Notice of Allowability	Application No.	Applicant(s)	
	10/069,086	WEIDMANN ET AL.	
	Examiner	Art Unit	
	John Juba, Jr.	2872

Examiner's Amendment

Reasons for Allowance

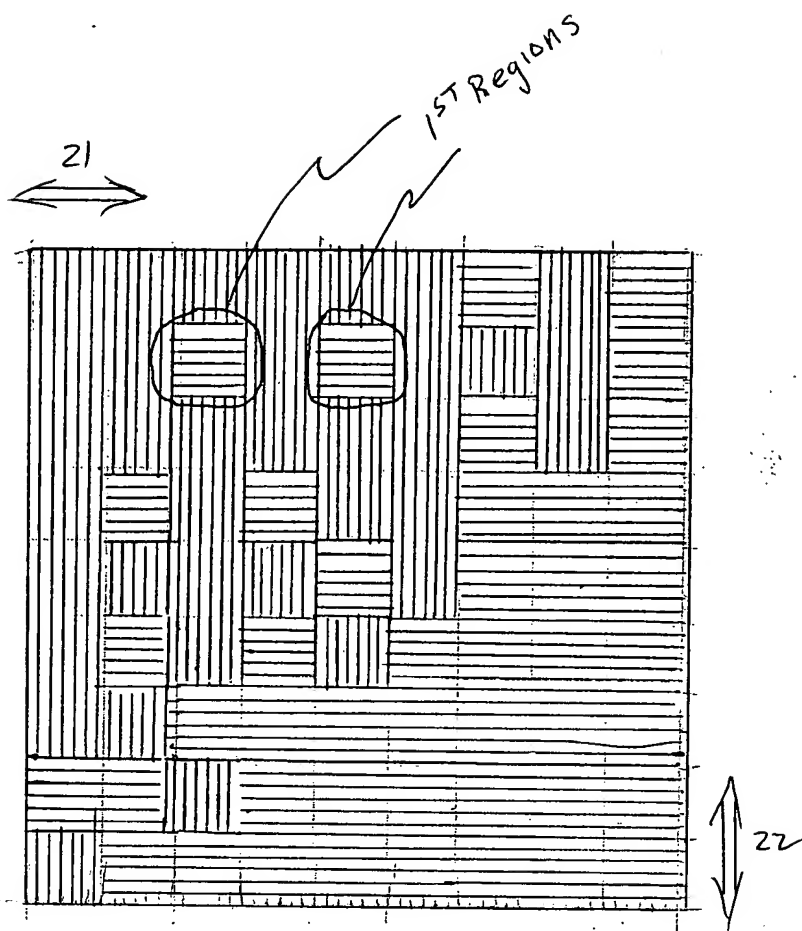
The examiner had previously relied upon Figure 8 of Kawama, et al (U.S. Patent number 5,725,006) as disclosing the structure of at least claim 38. Figure 8 of the reference is an alternative embodiment of Figure 6, and the examiner has sketched the structure disclosed in the reference, wherein the horizontal lines correspond to the horizontal grooves, and the vertical lines correspond the vertical grooved. The examiner has encircled "1st regions" intended to correspond to the first subsections, which alternate in a first direction (left to right) with second subsections, which comprise the vertical grooves. Arrow (22) shows the direction of preferential reflection for the first subsections, which is different than the reflection characteristic of the second subsections (which is preferentially in the direction of arrow 21). As shown, each of first subsections may be considered as borrowing a secondary V-shaped groove extending in a second direction (top to bottom), perpendicular to the first direction, and extending along the length of an edge of the first subsections. However, it should be clear that the second subsections are ridged and not "substantially planar". Even treating an *inclined*

planar surfaces of the vertical ridges as second subsections, it cannot be said that the first and second subsections (plural) are “alternately” disposed on the substrate. Rather, a single first subsection alternates with two second subsections, followed by a plurality of second subsections in succession.

Although the reference discloses other embodiments wherein there are planar regions, it appears that only *impermissible* hindsight would motivate one to select specific structures from one embodiment and combine them with specific features in another embodiment so as to coincidentally meet the claimed structure. To do so would be to use Applicants’ disclosure as a roadmap to reconstruct the claimed structure, since the prior art fails to provide any motivation to make such a combination.
